George Haddaway Drive Reconstruction Project Proposed Change Order #1

August 25, 2020

Proposed Change Order

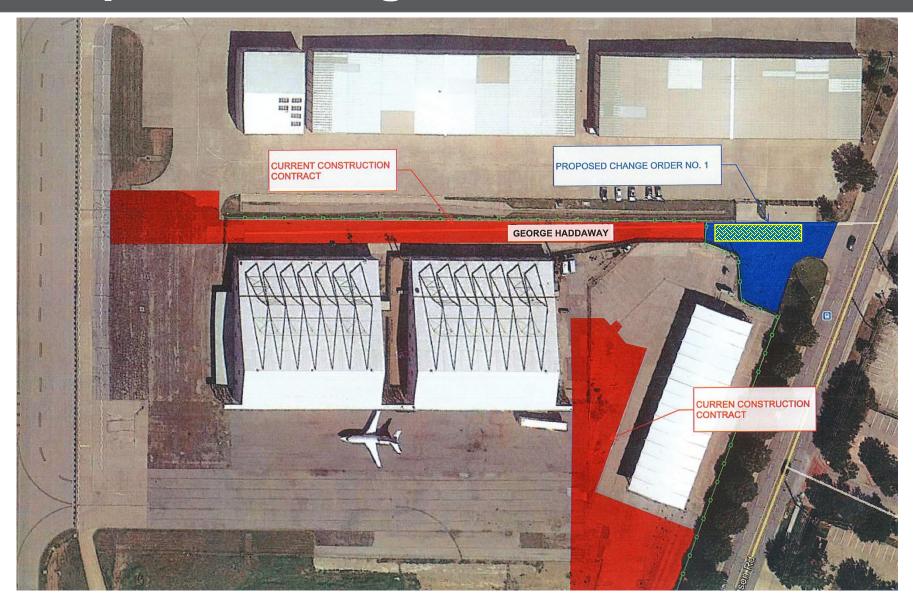
Proposed Change Order 1:

reconstruction of entire landside fuel farm entry area (785 s.y. of concrete paving)

Photographs of Change Order #1 Area

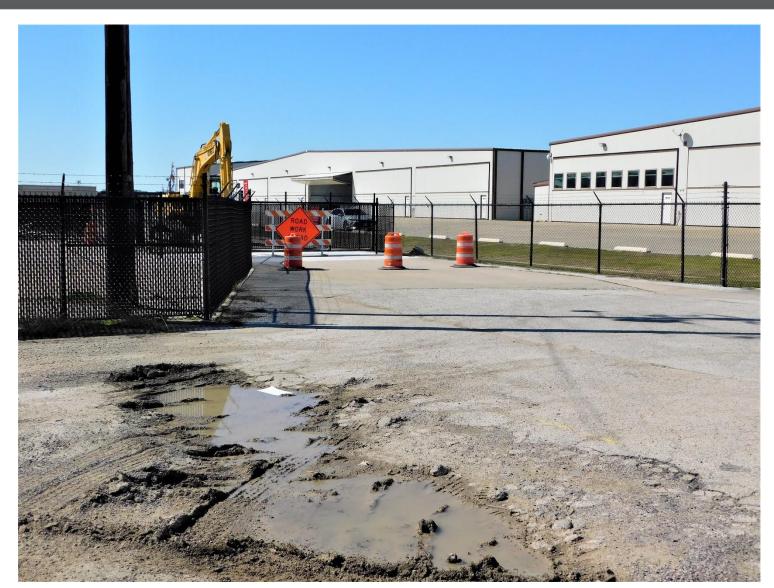
Left: view of relocated Gate 3. **Above**: failure at south edge of entry from Addison Road. **Below**: view from George Haddaway Drive towards Addison Road.
